**DECISION DOCUMENT**

**TWENTY-SIX NO FURTHER ACTION SITES**

SEPTEMBER 2001

Parsons Engineering Science, Inc  
30 Dan Road  
Canton, Massachusetts 02021

FIGURE 2-1a  
NO ACTION SITES  
PLANNED INDUSTRIAL DEVELOPMENT AREA

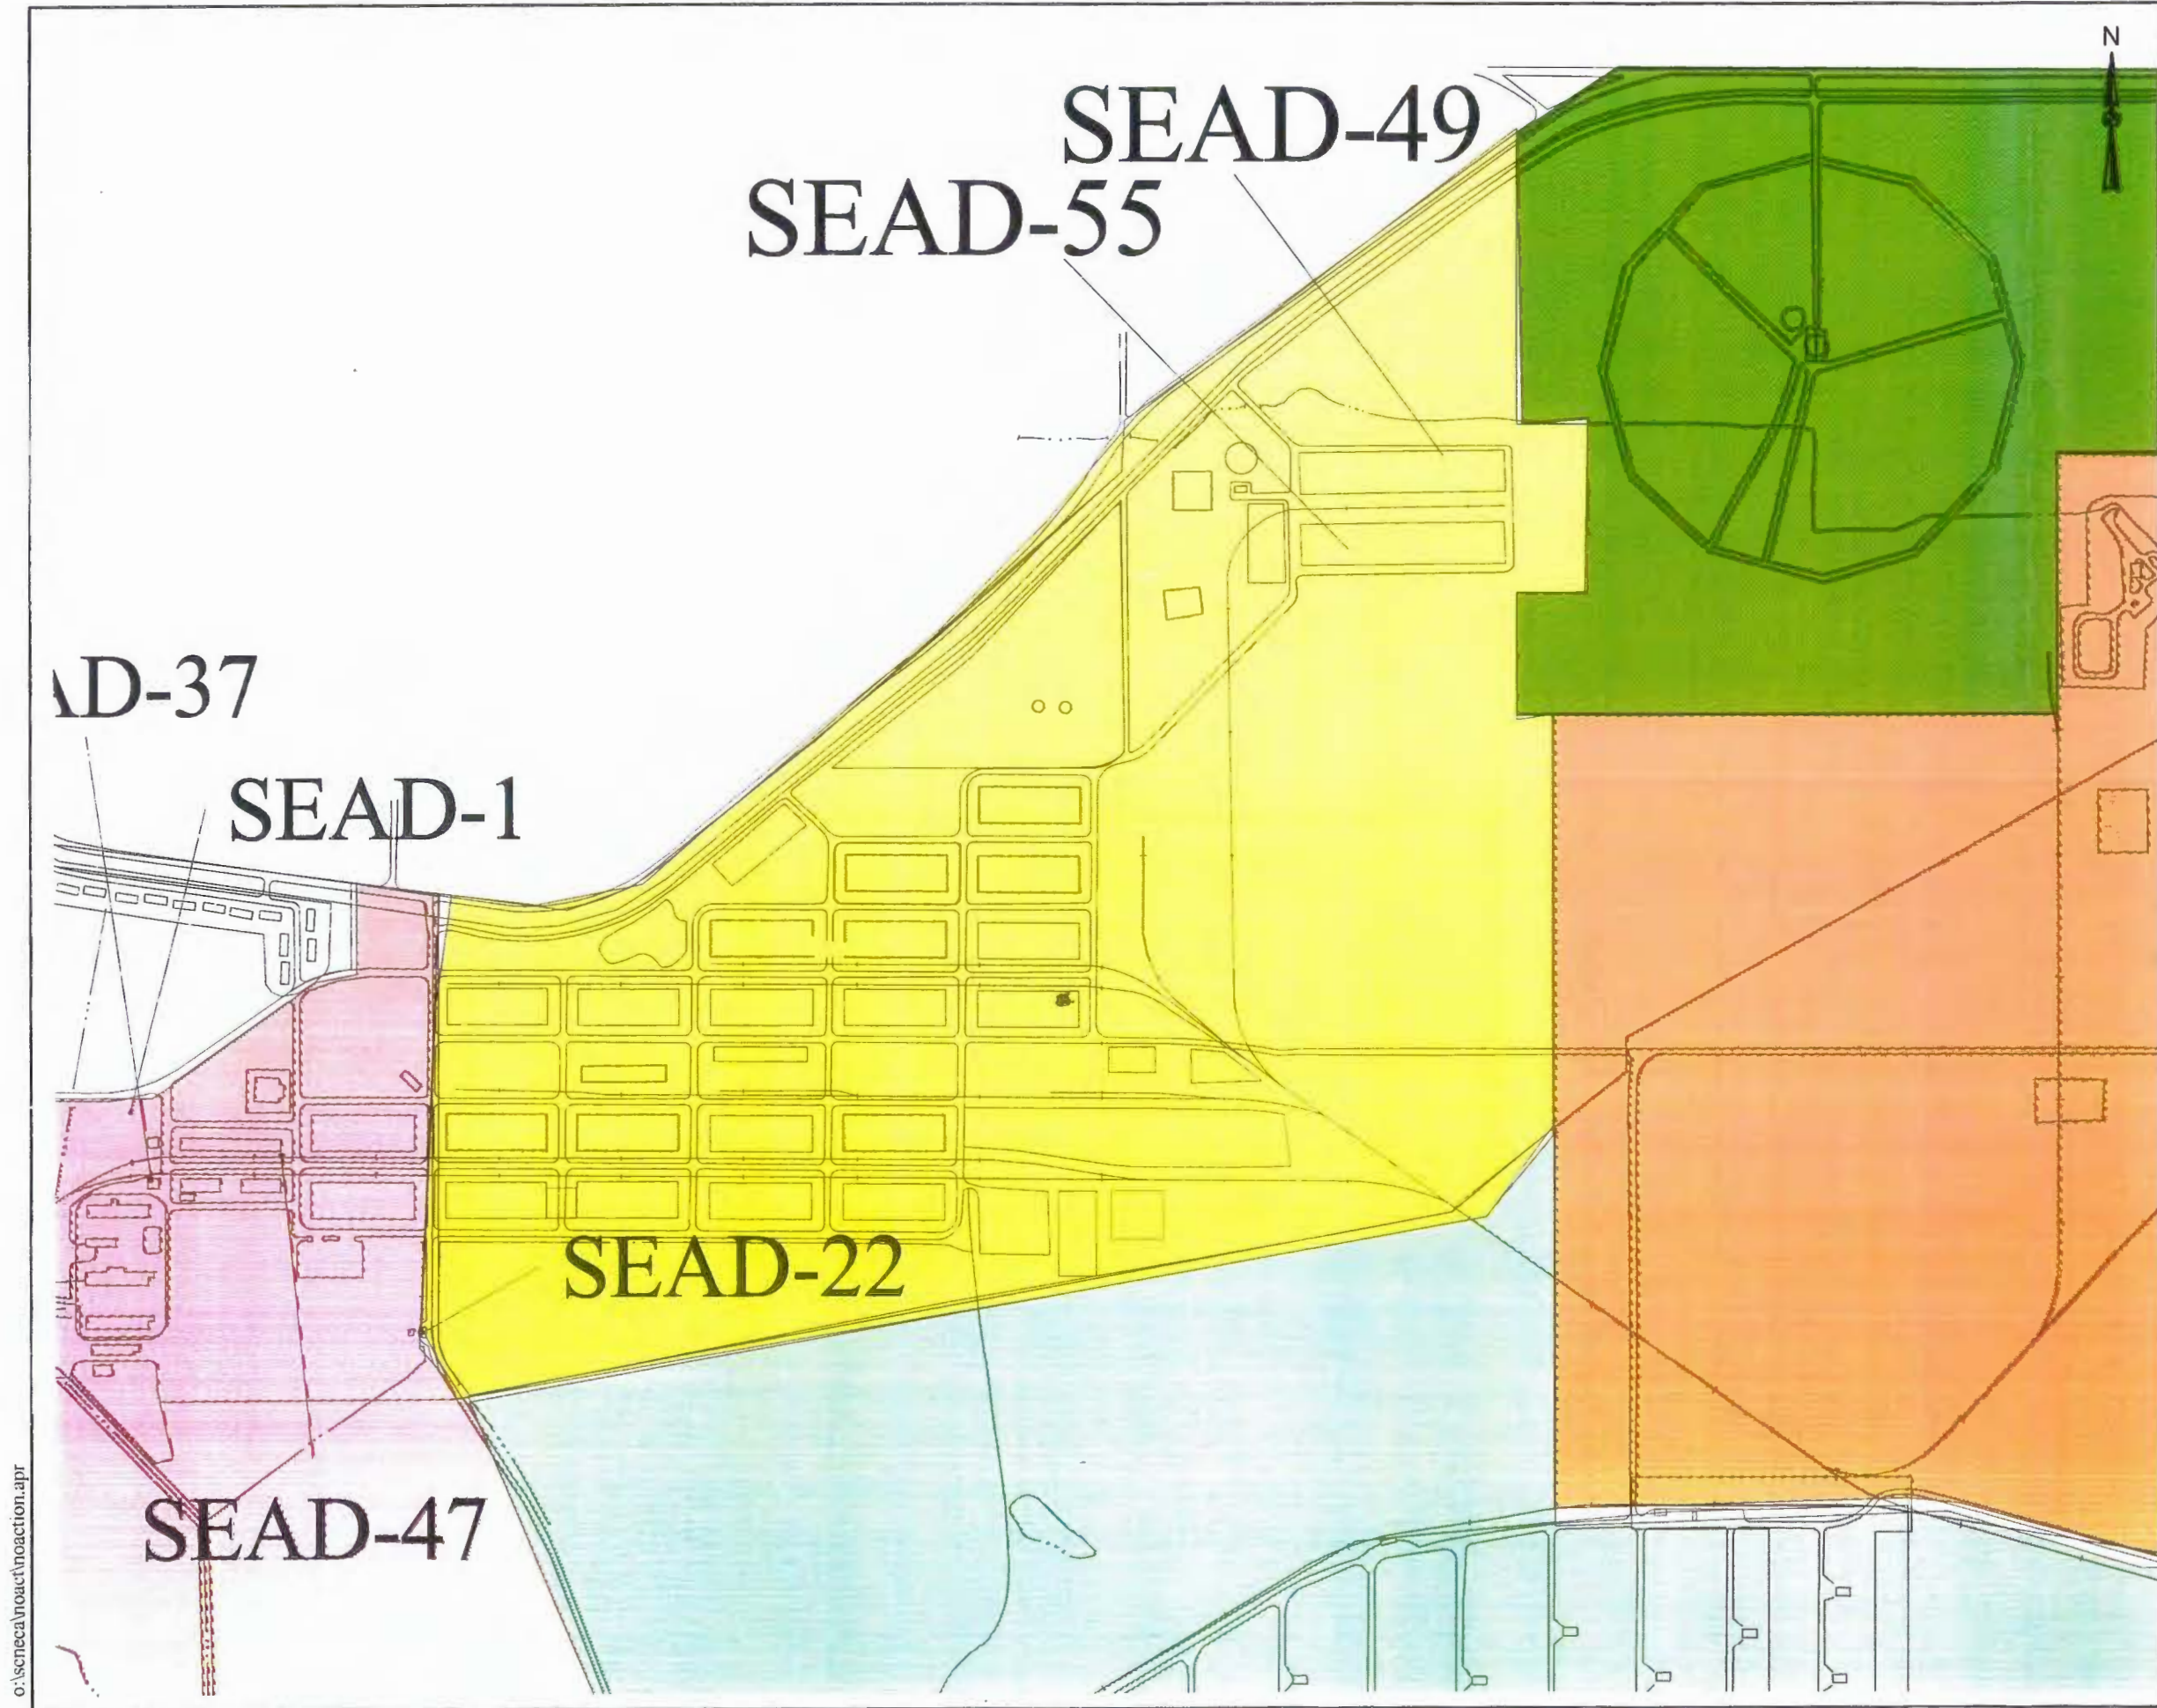
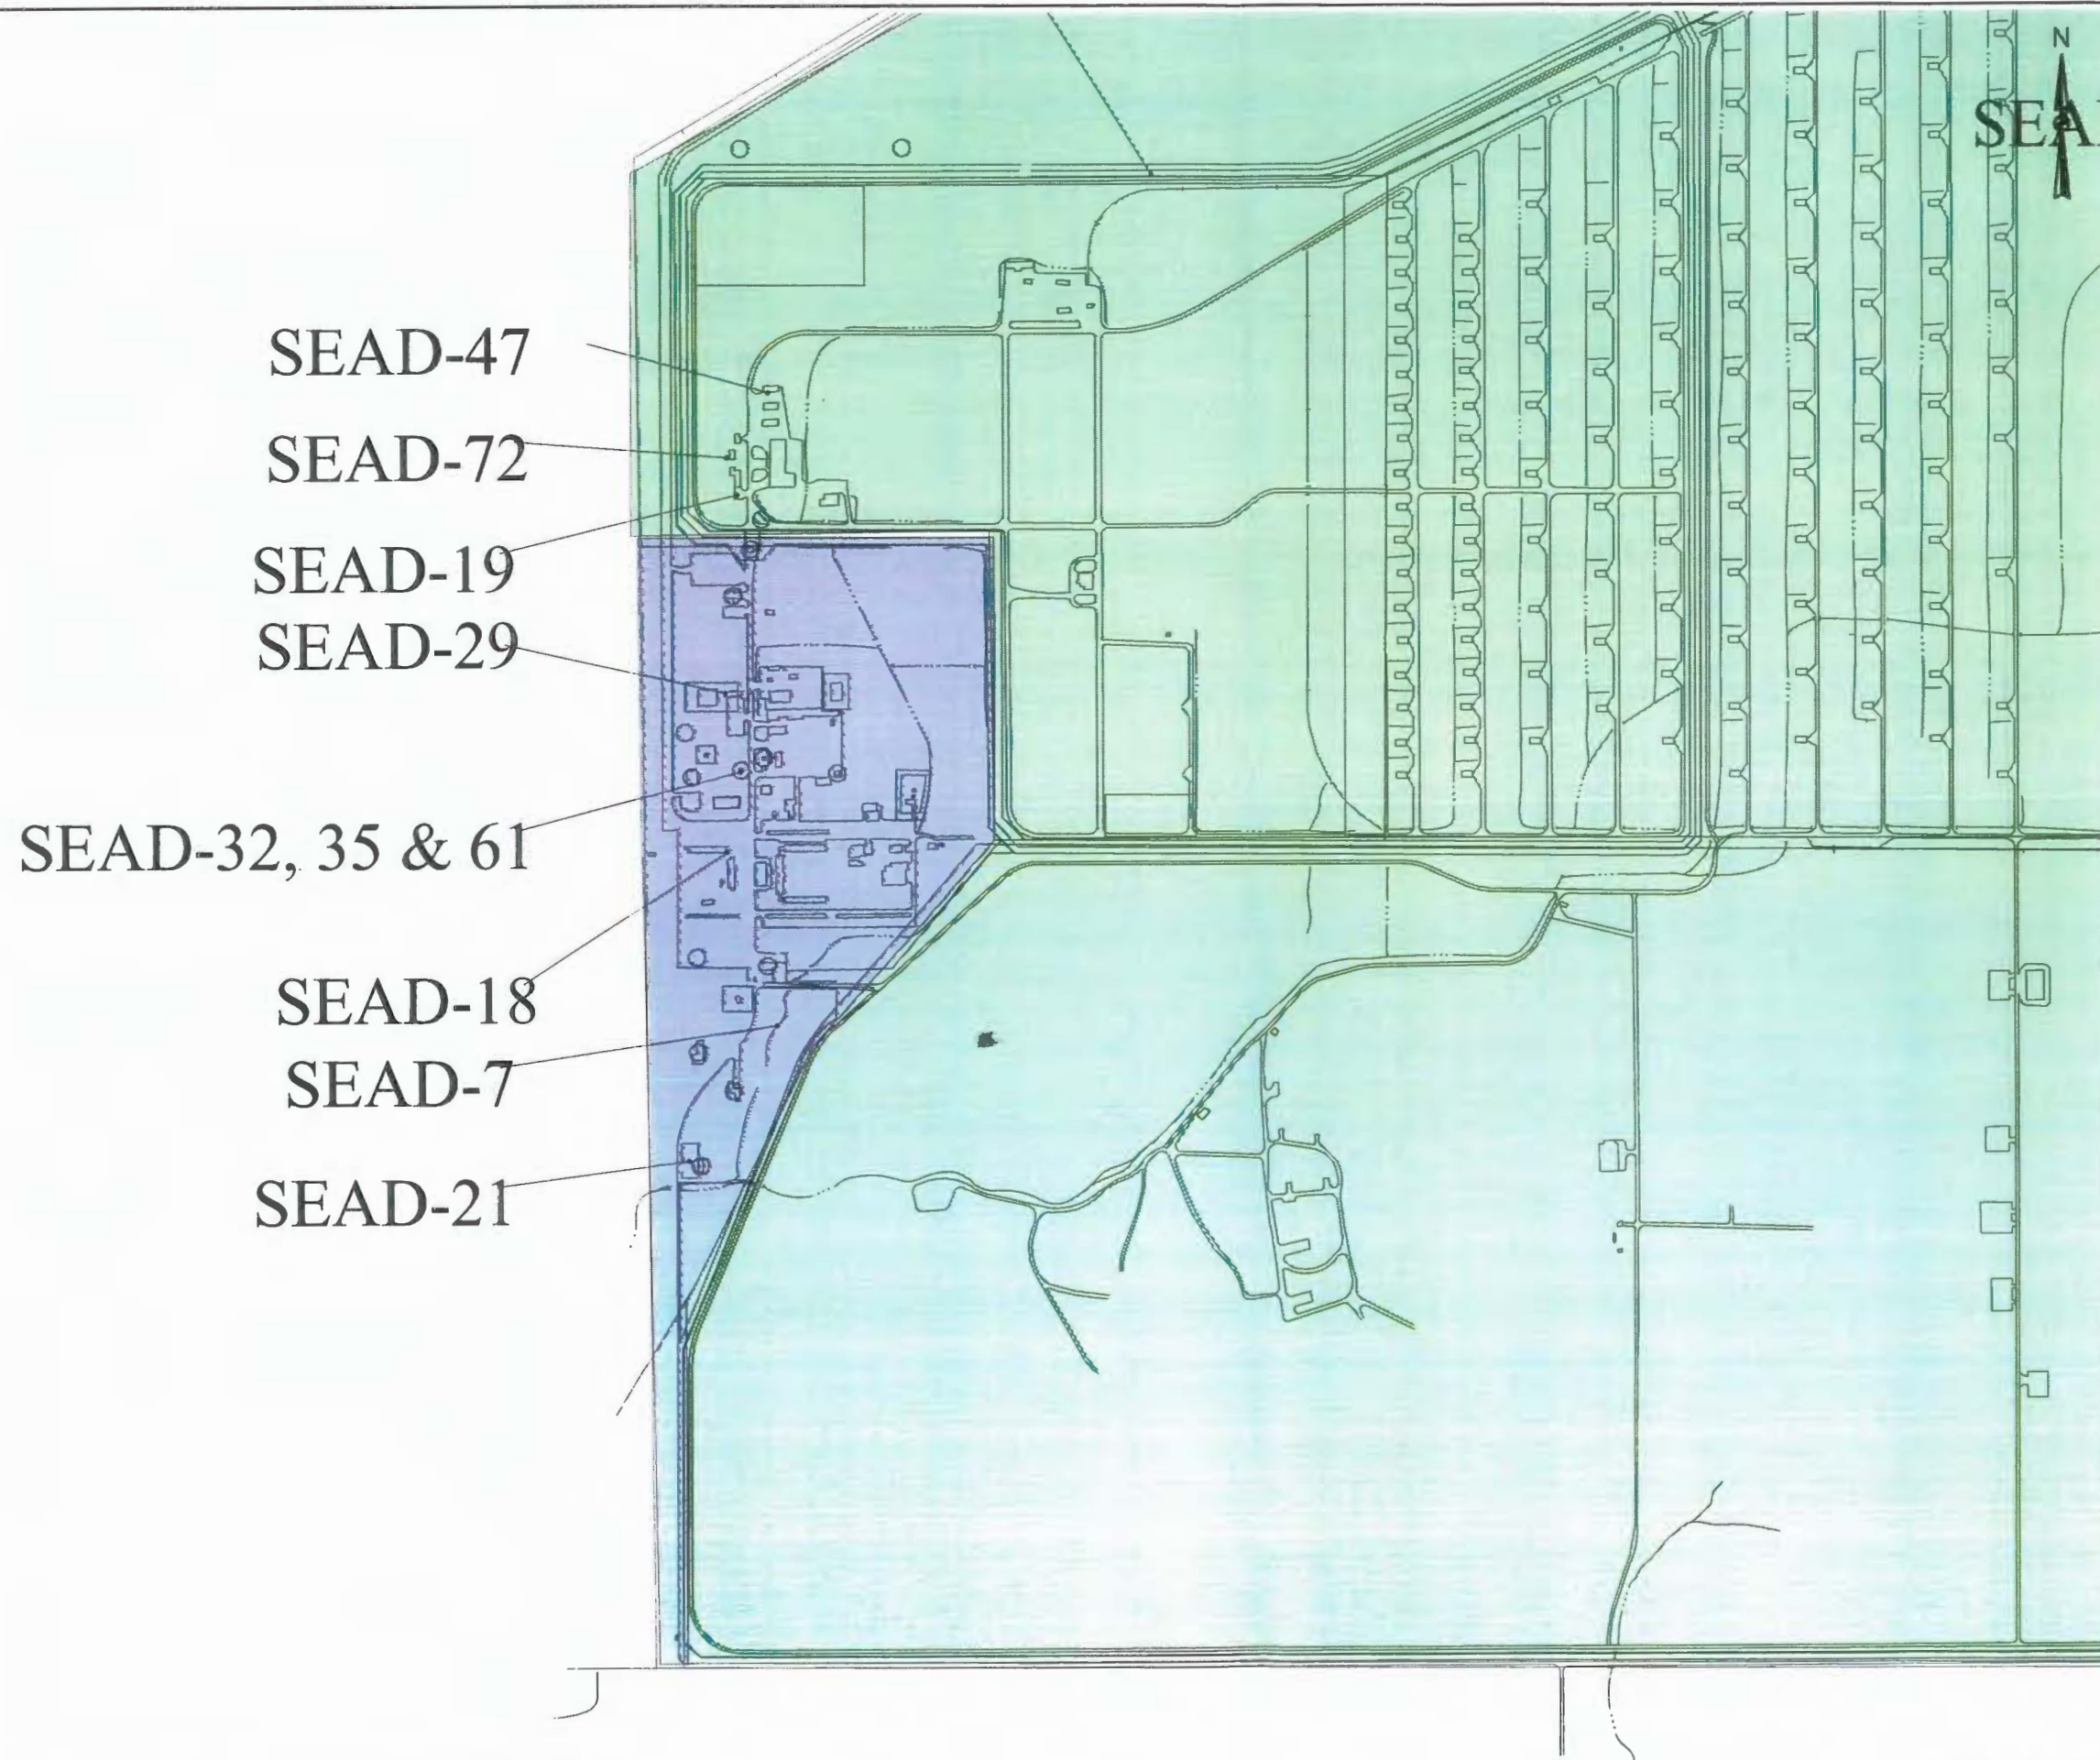
1. There seems to be a typographical error on the number for the first figure of Chapter 2. Referenced Figure 2-1 cannot be found in the document. Please include more specific maps for the different areas (i.e.. North End, PID, Warehouse, Q, etc.).
